AMENDMENT 1
14 July 1980

MILITARY SPECIFICATION

MODULES, STANDARD ELECTRONIC

DIODE, PAIRS, DIGITAL, KEY CODE KDF

FIGURE 4. Frame continuity test for table III.

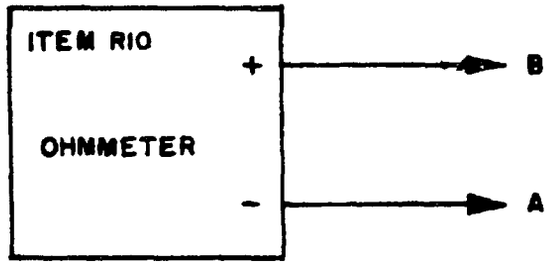
* FIGURE 4: Delete and substitute figure 4 as printed on page 3 of this amendment.

NOTE: Penetrate the anodized finish of the module fin with a sharply pointed probe and measure the resistance between the fin and the pin.

FIGURE 5. Forward voltage drop test circuit for table IV.

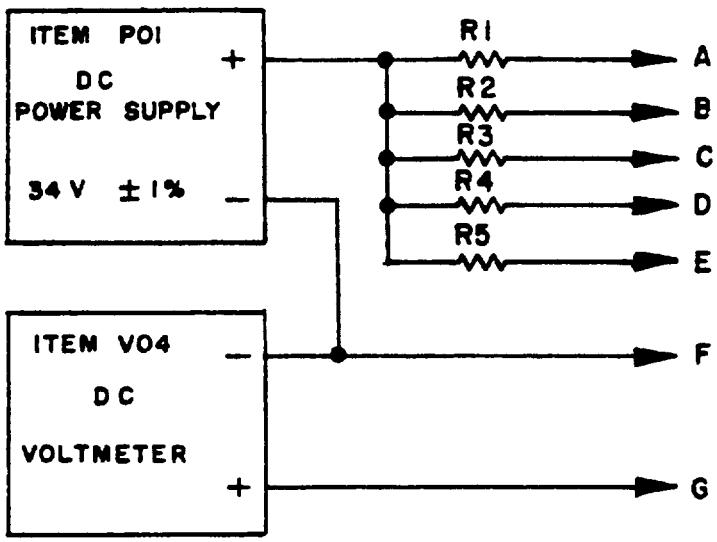
* FIGURE 5. Delete and substitute figure 5 as printed on page 4 of this amendment.

NOTES:
1. R1 = 68.1 kΩ ±1%, 1/4 W.
2. R2 = 11.0 kΩ ±1%, 1/4 W.
3. R3 = 3.32 kΩ ±1%, 1/2 W.
4. R4 = 332Ω ±1%, 4 W.
5. R5 = 133Ω ±1%, 10 W.

FIGURE 6. Reverse current test circuit for table V.

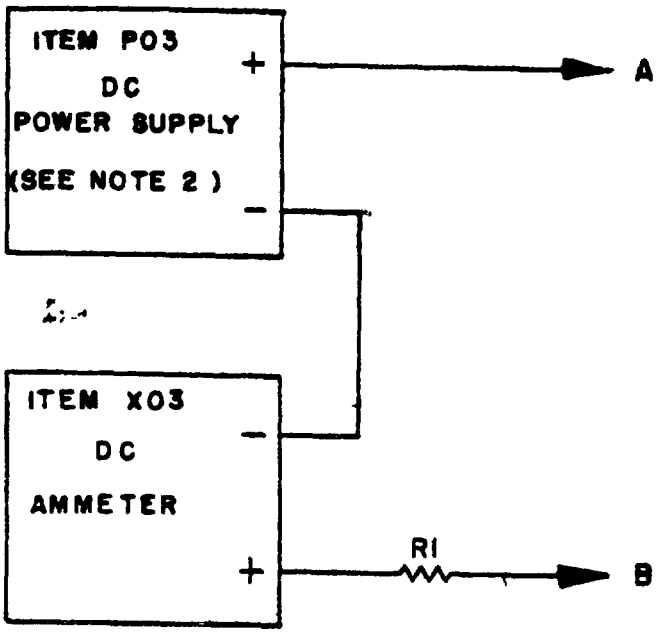
FIGURE 6: Delete and substitute figure 6 as printed on page 5 of this amendment.

High voltage (400 Vdc) will be present at the output binding posts of item P03 during test condition J. Always reduce the output voltage to zero volts before connecting and disconnecting the leads.

NOTES:
1. RT = 100 kΩ ±1%, 1/4 W.
2. For test conditions J1-J24 set item P03 at 400 V. For test conditions K1-K24 set item P03 at 10 V.
